Shorne Parish Council

Application Ref: 20260521

Nuralite Industrial Estate Canal Road Higham Rochester Kent ME3 7JA

Application for approval of condition 2, 5, 8, 9, 11 and 12 attached to planning permission reference number 20250721 relating to full details of the road improvements works at the Canal Road / Chequers Street / Church Street /Lower Rochester Road junction (2), full details of the phasing of the development (5), a comprehensive Demolition and Construction Logistics Plan covering all environmental impacts (8), a full Construction Traffic Management Plan (9), an updated preliminary ecological appraisal and review and of the site wide mitigation strategy (11) and a strategy to deal with the potential risks associated with any contamination of the site or the relevant phase (12).

Extract from MAGIC Map showing Ramsar site boundaries

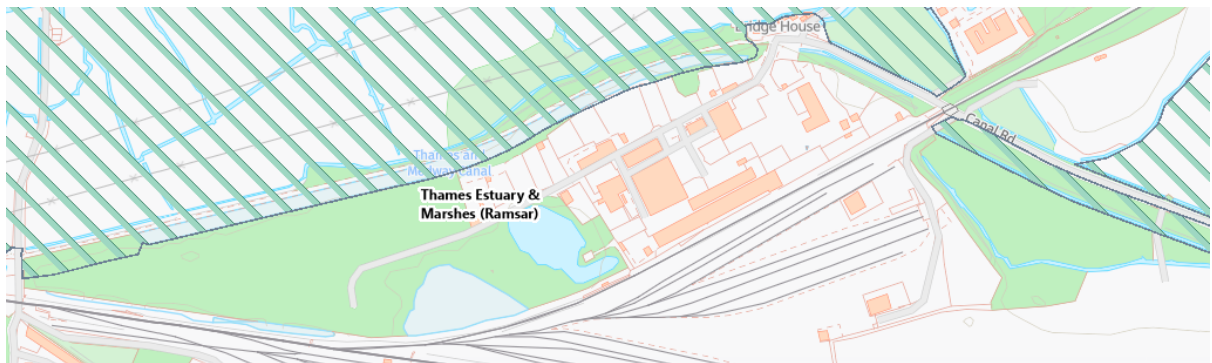
- The Demolition and Construction Logistics document relates to this Condition.
- We have concerns about potential impacts on users of the footpath and national cycle route immediately to the north of the site.
- The document refers to the Nuralite site being adjacent to the SSSI and Ramsar site however the boundaries of the Ramsar site extend into the Nuralite site itself.
- Additionally, there is Ramsar land both sides of Canal Road south of the railway bridge (only to the east on the north side) and this will be impacted by vehicle movements.
- We do not consider that these aspects are adequately covered at present.

- The Preliminary Environmental Assessment refers.
- This is a desk study.
- The document notes that area of hardstanding have been created in various parts of the site, replacing grassland (sections 1.8.7-1.8.9). On the northern boundary of Nuralite these adversely involve the Ramsar site (see map above and “Remediation” sections below).
